Thank you for your correspondence related to Concept Site Plan application SP-8415-2020. Your correspondence will be included in the Council's record for their consideration. For information about the application, please visit the project page: <https://www.gaithersburgmd.gov/government/projects-in-the-city/10-and-14-east-deer-park-drive> .

DEVOL FUNERAL HOME
#10 & #14 E DEER PARK DRIVE
GAITHERSBURG, MD 20877

STORMWATER MANAGEMENT CONCEPT PLAN

Re: Devol Funeral Home
Concept Sediment Control Plan No. SEC-8417-2020
Concept Stormwater Management Plan No. SWM-8418-2020
Conditional Approval

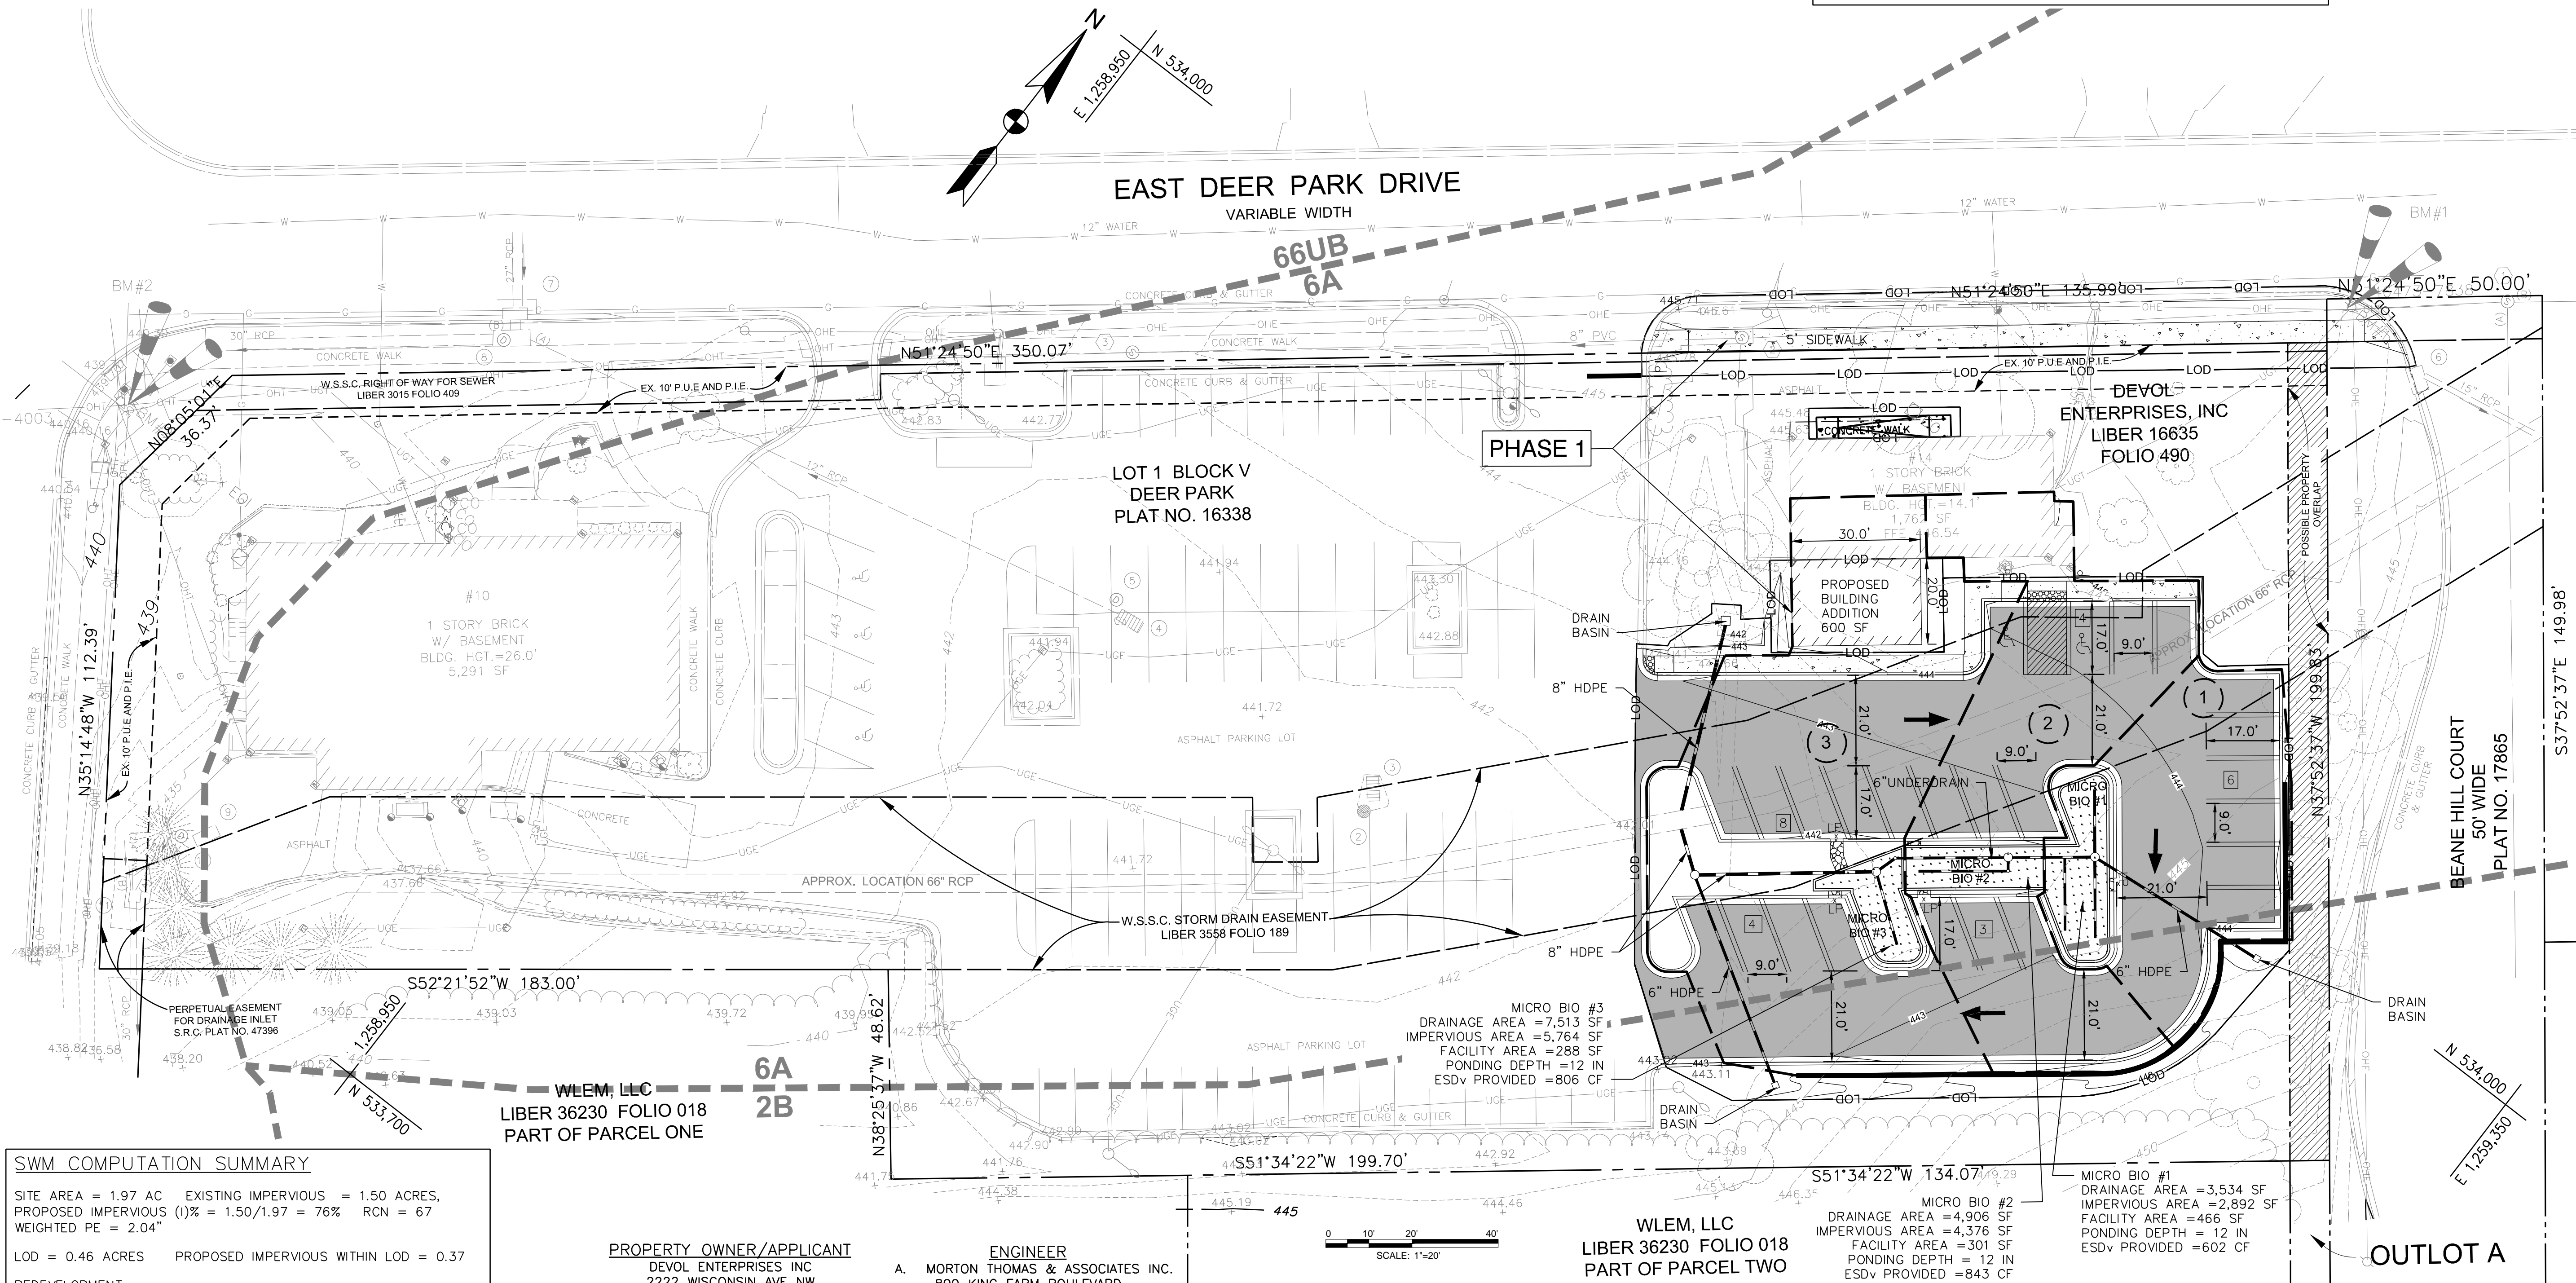
Based on a review by the City of Gaithersburg Environmental Services Division, Stormwater Section, the Concept Sediment Control and Concept Stormwater Management Plan for the above mentioned site are **acceptable**. The plan proposes to meet required stormwater management goals via the used of ESD to the MEP with the use of planter box micro bioretention.

The following items will need to be addressed during the preliminary stormwater management plan stage:

1. A detailed review of the stormwater management computations will occur at the time of preliminary plan review.
2. Confirmation of vertical design elements including stormwater facility depths and relationships to existing drainage infrastructure.
3. Coordination with Engineering Services regarding storm drain connections to the existing 66" storm drain and verification of hydraulic grade lines.
4. Provide stormwater conveyance such that stormwater facilities are placed off line from other drainage infrastructure.
5. Geotechnical report with soil borings, consistent with MCDPS soil testing guidelines for stormwater management practices, must be provided prior to preliminary plan approval.
6. Facilities shall be consistent with MCDPS draft guidelines for safe placement of surface fed stormwater management practices.

7. Provide either complete sediment and erosion controls for all phases no matter limits of disturbance, or specifically exclude first phase if less than 5,000 SF from the sediment and erosion control plans while maintaining reference to the scope of work and general intent to provide sediment and erosion control measures. All phases of work shall be show in detail on stormwater management plans.
